Project No. TS - 4993

Memorandum

SITE: Olympic Drive (SR 305) between Harborview Drive SE & Winslow Way E
Bainbridge Island, WA 98110

RE: Olympic Drive Tree Retention Analysis – Ferry Terminal Access Road
Improvements

Photo 1. The subject trees looking south.

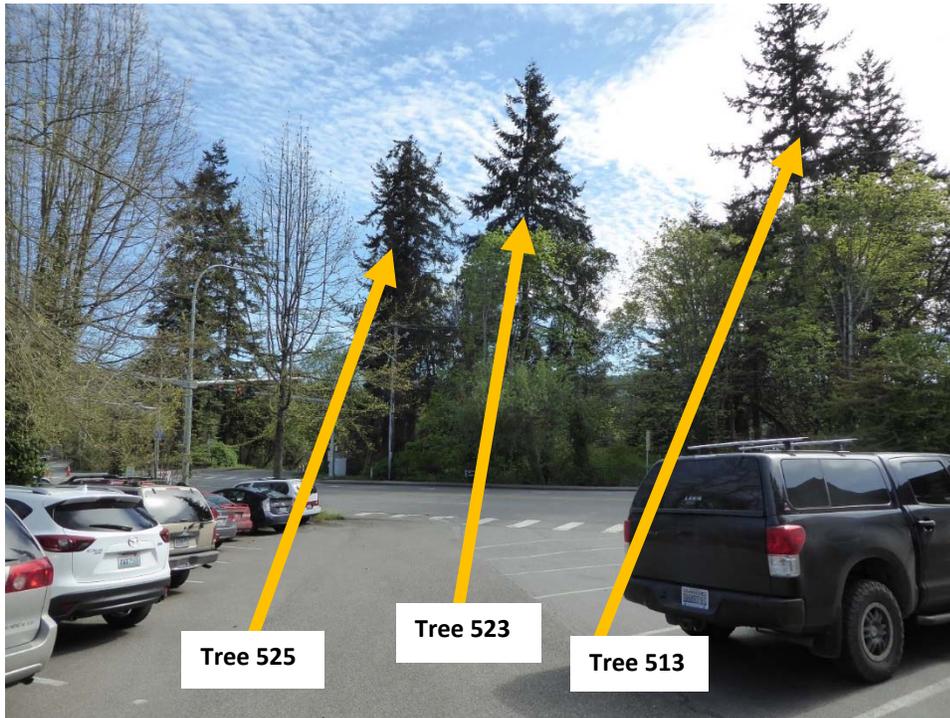
I assessed three trees, numbered 525, 523, 513 (Photo 1). These were originally proposed for removal with one tree (523) to be left as a snag in a report generated by our office. Due to concerns raised by the public we were asked to assess if there might be a way to retain the trees.

We used a soil probe to determine that the soil depth which could support trees roots is approximately 40 inches or greater, to the north side of the subject trees (Photo 2).
